HUNTER VALLEY OPERATIONS CONTINUATION PROJECT

SUBMISSIONS REPORT
NOVEMBER 2023

HV Operations Pty Ltd

H190408 RP#1

Figure 4.31 Background PM₁₀ and PM_{2.5} concentrations as inferred from the measurement data

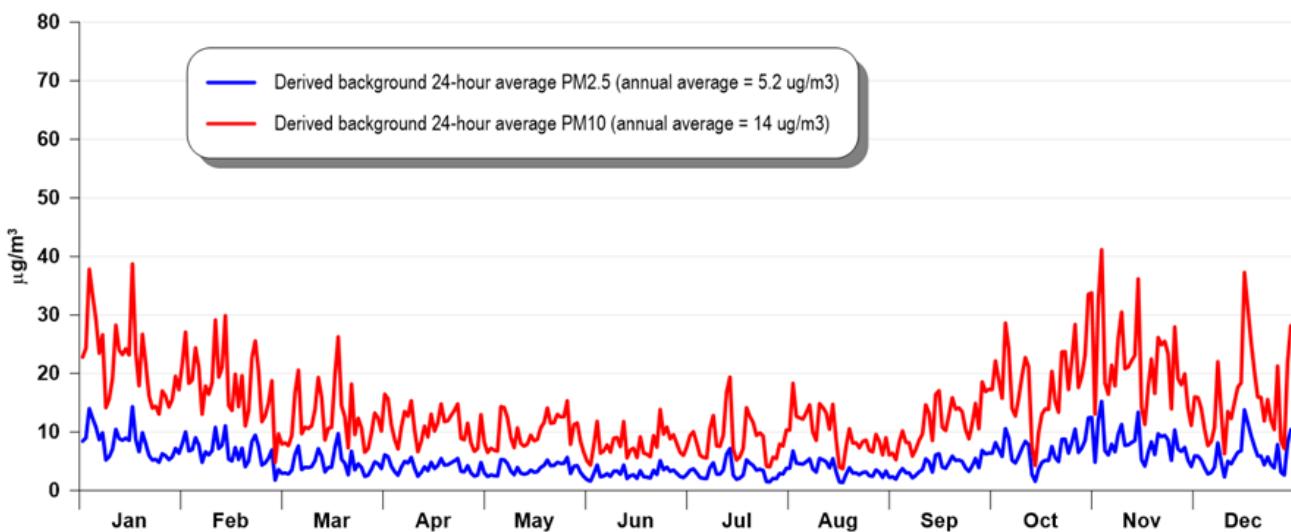
For PM₁₀, an hourly variable background dataset was derived for 2014 from three local monitoring stations, as per Figure 18 of the AQGHGA. For PM_{2.5}, where 2014 data did not exist, it was necessary to make an assumption that the variation in hourly PM_{2.5} concentrations would follow the variation in hourly PM₁₀ concentrations. This involved examining each hourly PM₁₀ concentration and calculating a corresponding hourly PM_{2.5} concentration based on the annual PM_{2.5} to PM₁₀ ratio, where the annual PM₁₀ was 14 µg/m³ (derived from DPE monitors) and the annual PM_{2.5} was 5.2 µg/m³ (derived from the Kelly monitor). This approach also prevented any instances of PM_{2.5} concentrations exceeding PM₁₀ concentrations.

Figure 4.31 provides an alternative representation of the background PM₁₀ and PM_{2.5} concentrations. It can be seen from this figure that the PM_{2.5} concentrations follow the same trend as the PM₁₀ concentrations but scaled to match the local measurement data.
